Solicitation Addendum

Addendum No.: 2
Solicitation No.: 23-R081797LP
Solicitation Title: Blackstone Park Chainlink Fence Backstops
Addendum Date: June 15, 2023
Procurement Contact: Leslie Peer

8'-0" O.C. MAX, TYP. 30'h Backstop detail w/ 6' 45degree header

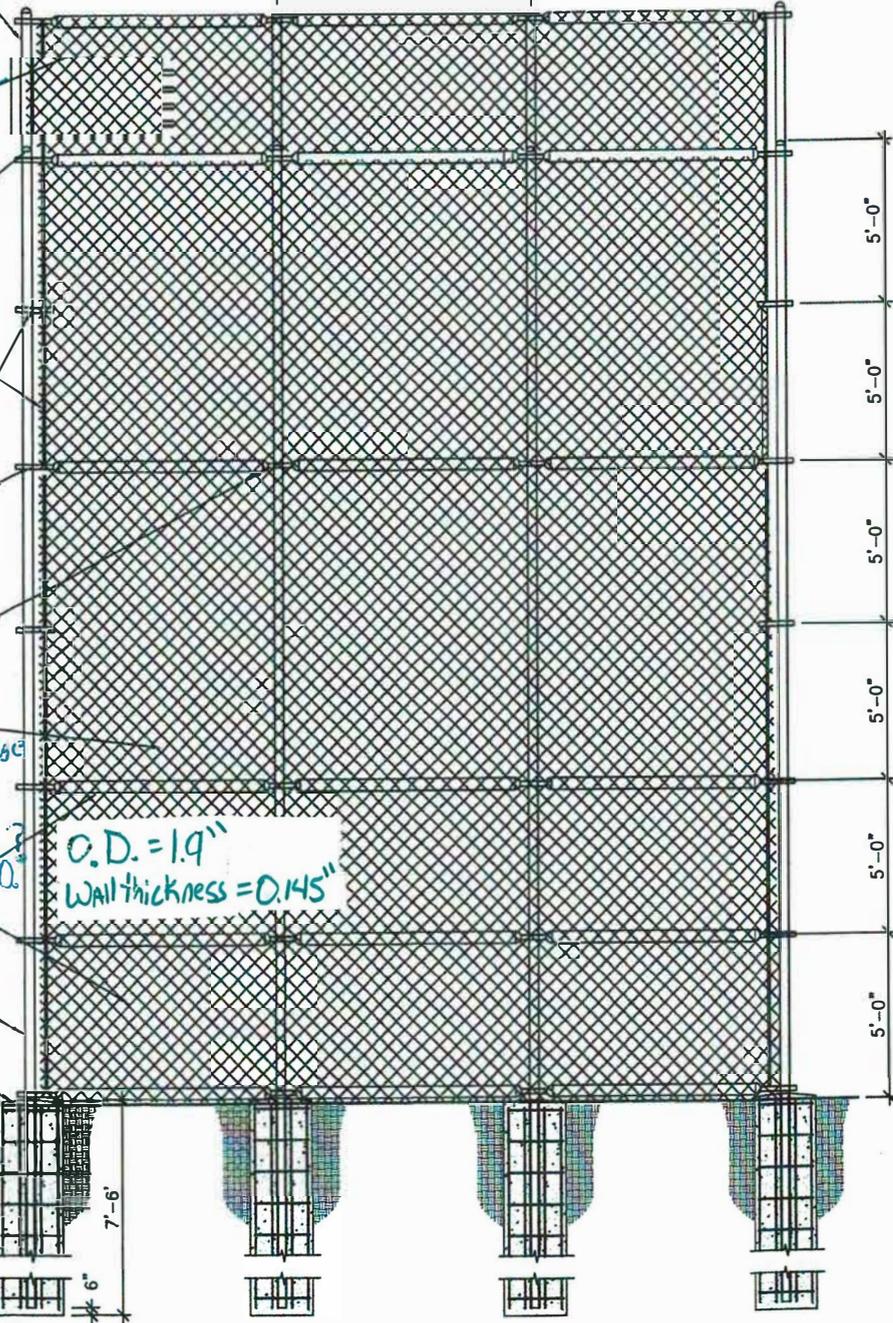
- Q5. Is this 2.5" O.D., or 2" O.D.? See Attachment Backstop Questions number 5.**
- R5. The O.D. is 2.375", wall thickness is .154".
- Q6. What is the Core Size? See Attachment Backstop Questions number 6.**

- R6. #8 is a solid galvanized wire. It is not hollow core.
- Q7. Is Core 09 Gauge? See Attachment Backstop Questions number 7.**
- R7. #8 is a solid galvanized wire. It is not hollow core.

- Q8. Is this 2" O.D. or 1-5/8" O.D.? See Attachment Backstop Questions number 8.**
- R8. O.D. is 1.9", wall thickness is .145".
- Q9. Shall the 6-5/8" posts be Sch 80, or Sch 40? See Attachment Backstop Questions number 9.**

2.5" O.D.?
or 2" O.D.?

6 #8 GAUGE FINISHED WIRE DIAMETER MAX. Core size?

8 1/2" STANDARD STL. PIPE RAIL TYP. 2" O.D. or 1-5/8" O.D.

Shall the 6-5/8" Posts be sch 80, or sch 40?

- R9. O.D. is 6.625" wall thickness .1562" (Schedule 120).

O.D. = 2.375"
Wall thickness = 0.154"

O.D. = 6.625"
Wall thickness = 0.562"
(Schedule 120)
